Technical Service Bulletin

Mazda North American Operations
Irvine, CA 92618-2922

| Subject: COOLANT LEAKS AT CYLINDER HEAD | Bulletin No.: 01-002/23 |

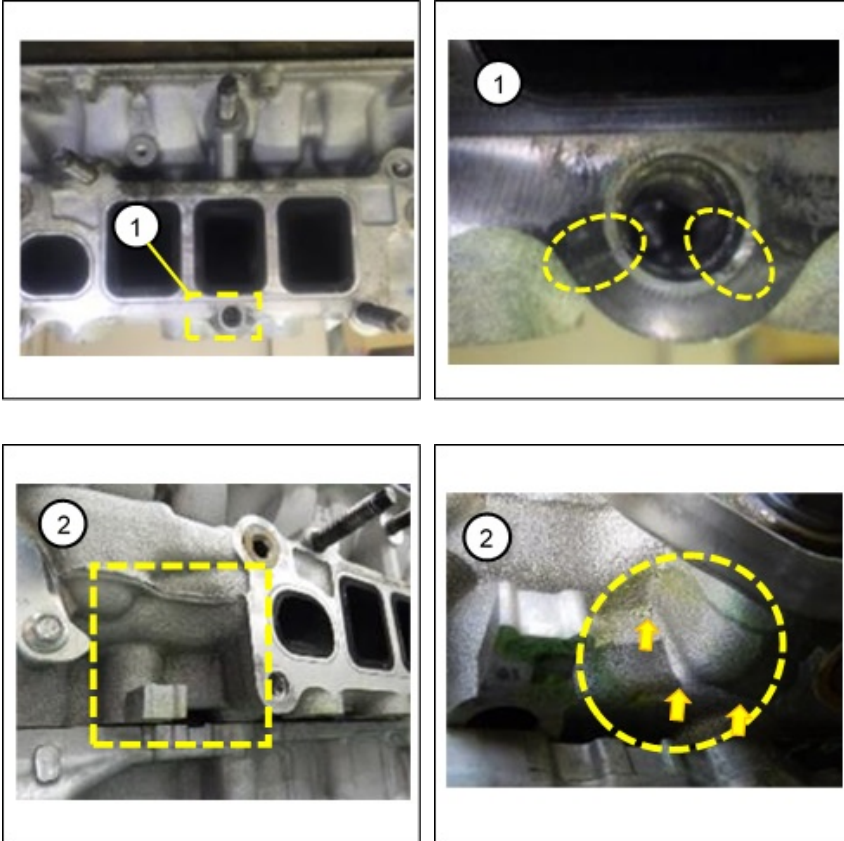
Some vehicles may have coolant leaks at the cylinder head around the exhaust manifold (as shown below). There may be cracks at the stud bolt hole (1) or at the outside of the exhaust manifold (2).

Cracks may be caused by:

- Deformation of the exhaust manifold during usage causing unexpected force to certain areas of the cylinder head.
- Residual stress generated during production in the cylinder head material may be greater than expected. The external force from the exhaust system when driving over bumps may cause unexpected force to certain areas of the cylinder head.

To eliminate this concern, the design of the exhaust manifold gasket and the cylinder head has been modified to reduce the force on the cylinder head.
